| Project name | Land North of Rectory Farm, Yatton | | |
| Design note title | Response to LLFA Comments dated 15th May 2023 | | |
| Document reference | 23257-HYD-XX-XX-TN-D-0001 | | |

DRAWING NO. (PROJECT CODE ORIGINATOR.DWG LEVEL/TIME/ROLE/NUMBER)
23257-HYD-XX-XX-DR-D-2001

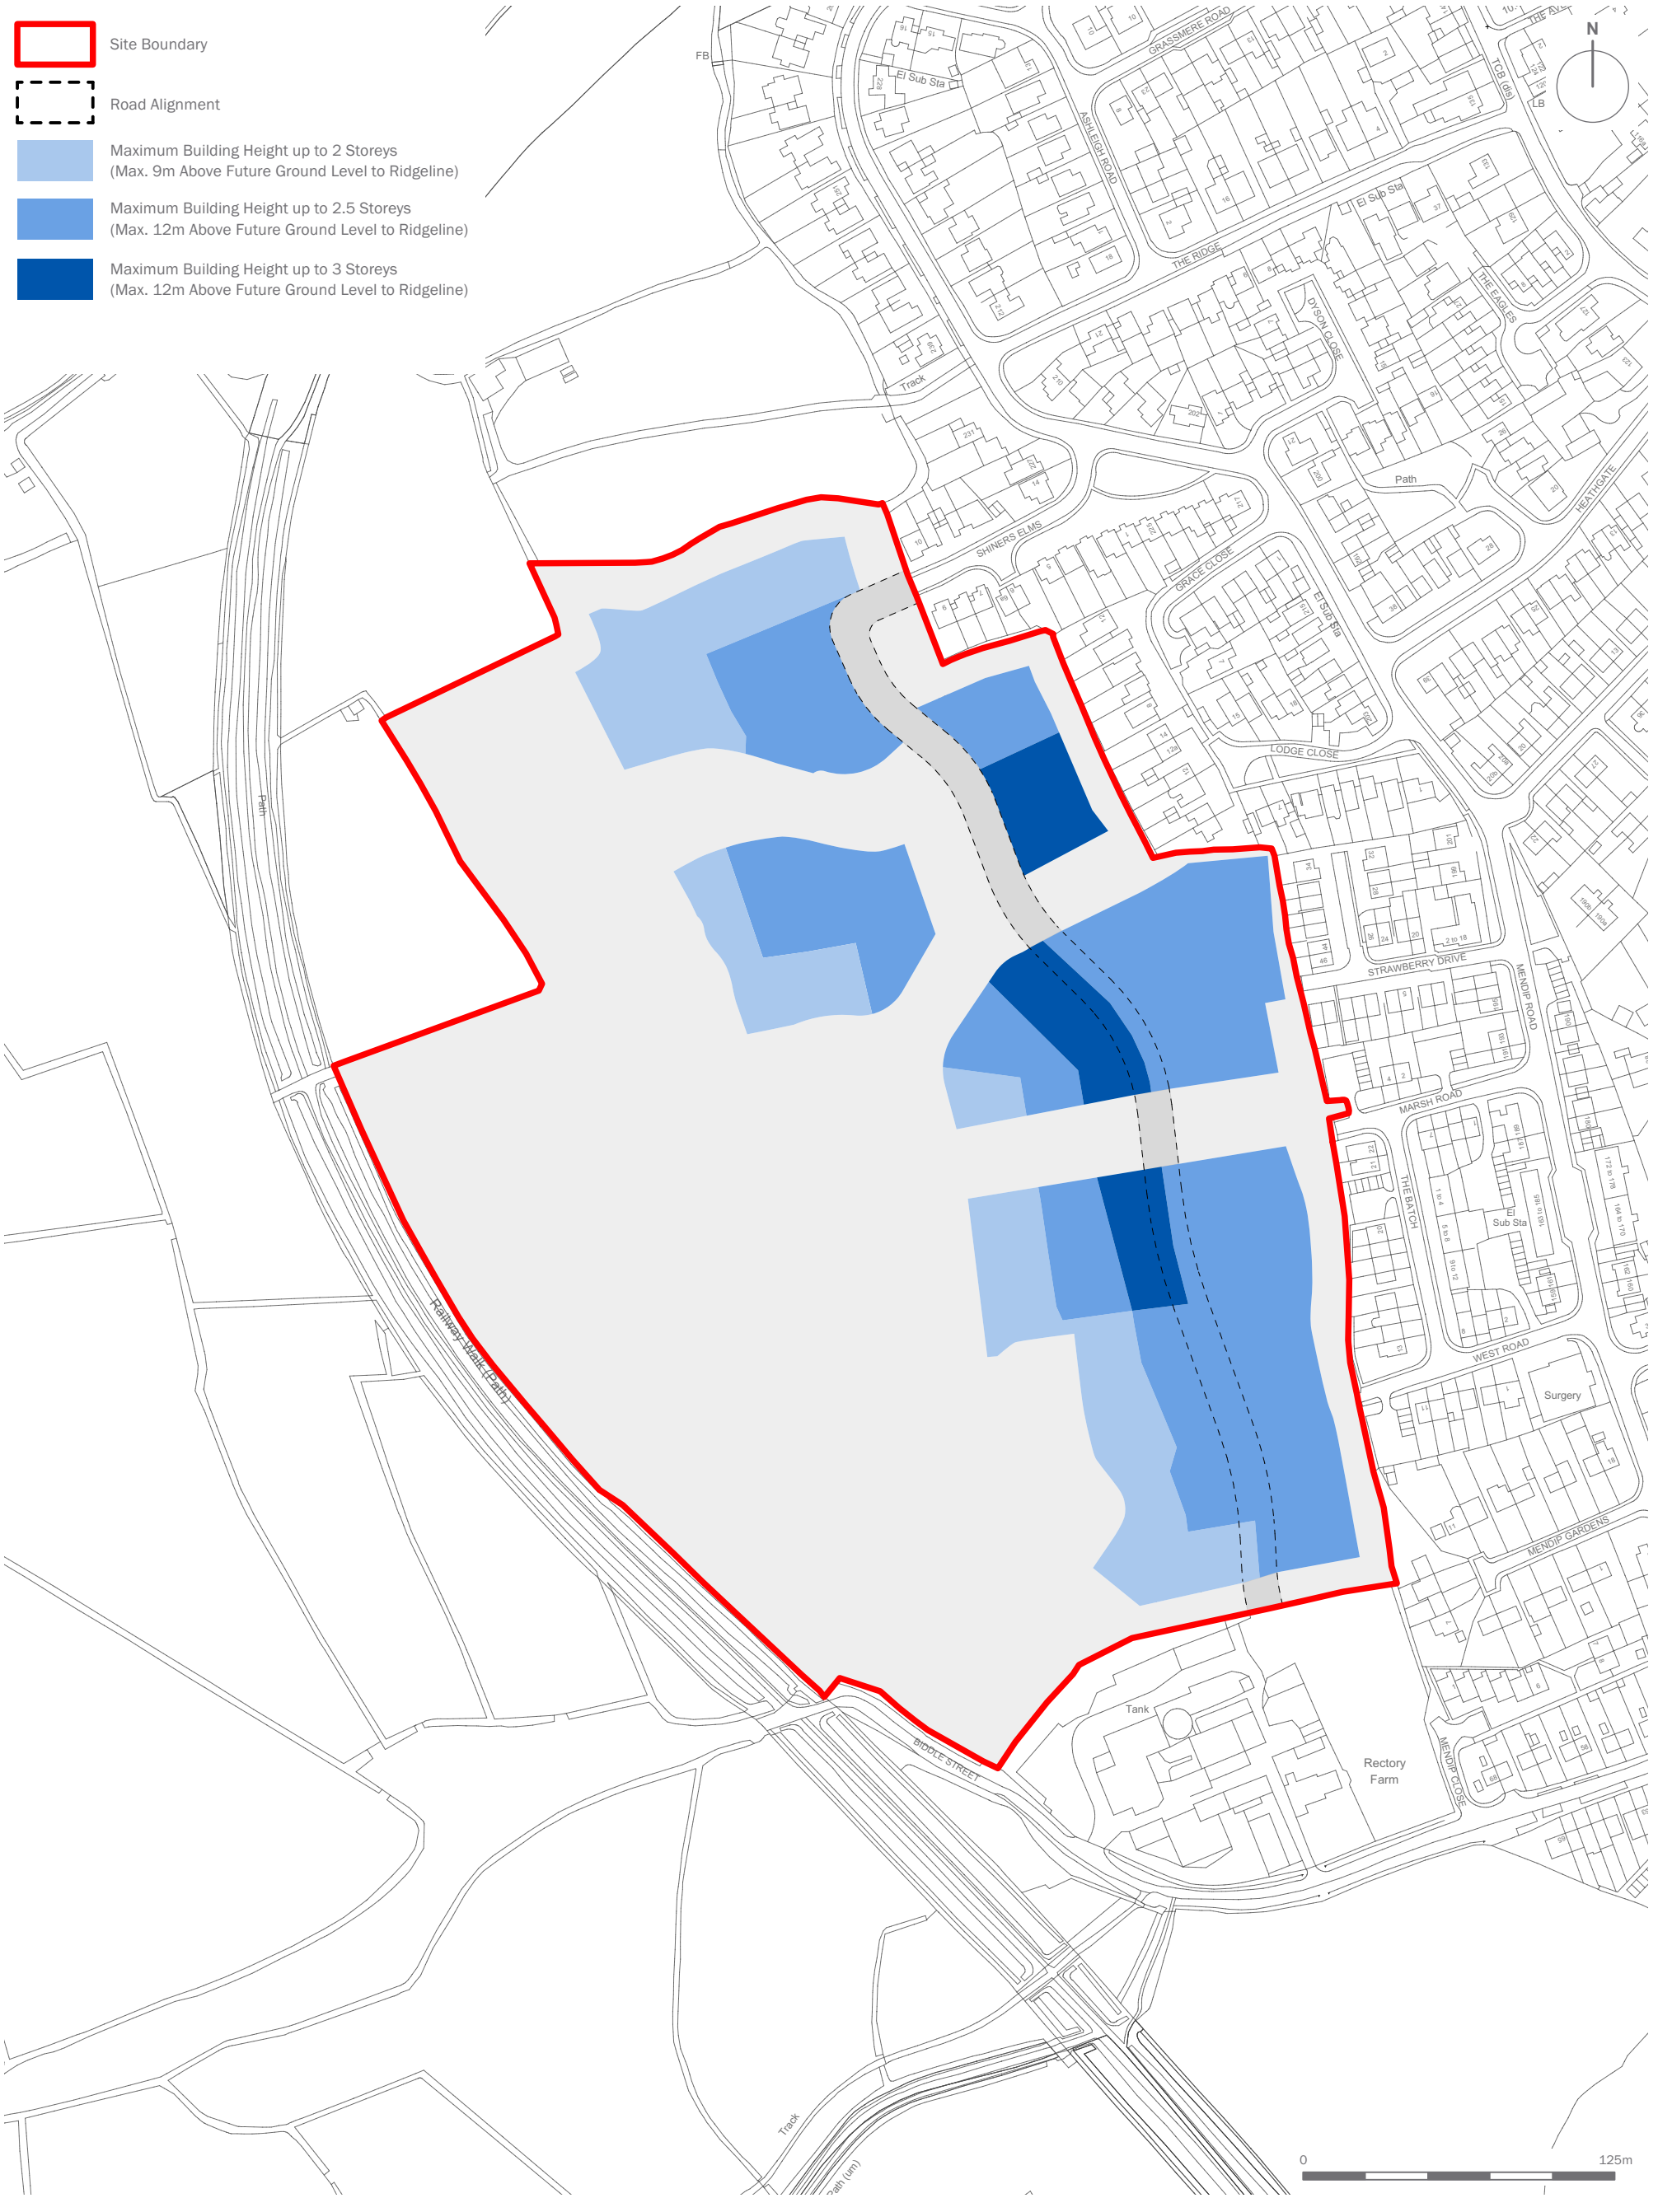
- There are concerns regarding the overall land raising that is proposed and the impact that would have on surface water flow routes from the urban extents of Yatton and how that will then impact on the rhyme network, accessibility for maintenance (access down to the rhyme maintenance strip level requires suitable slopes and ramps) and Wessex Water's surface water drainage outfalls and also the impact on Wessex Water's foul drainage network that crosses the site.

- 2.1.6 The proposed Drainage Strategy included with the original planning submission shows proposed diversions to Wessex Water public foul sewers. A copy of Hydrock drawing no. 23257-HYD-XX-XX-DR-D-2001-P05 is included in Appendix B of this Technical Note for information.

A Pre-Development Enquiry was submitted to Wessex Water prior to the planning application and the response was included with the Drainage Strategy report. There were no adverse comments.

Any diversion works will be carried out under Section 185 of the Water Industry Act.

Edp7842_d006c - Height and Scale Parameter Plan

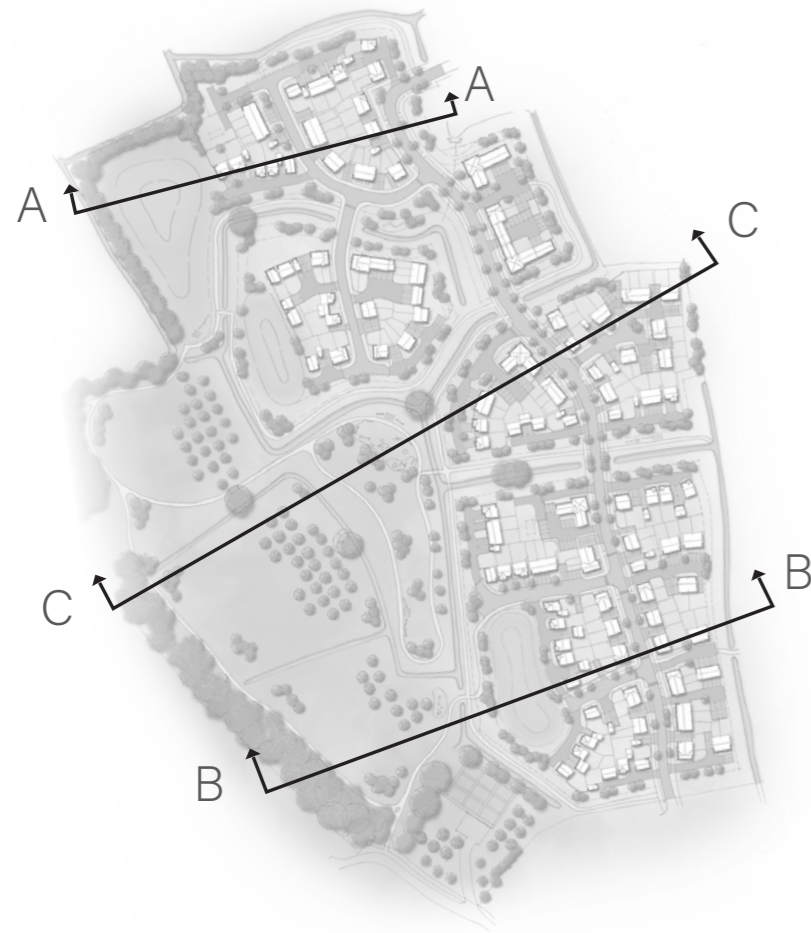
- A plan should be provided that shows the proposed land raising. The height and scale parameter plans should also include a relationship to the existing ground levels.

- 2.2.1 A copy of the EDP Height and Scale Parameter Plan plus extracts for the Design and Access Statement showing typical site cross-sections are attached in Appendix C indicating the extents of the proposed land raising.
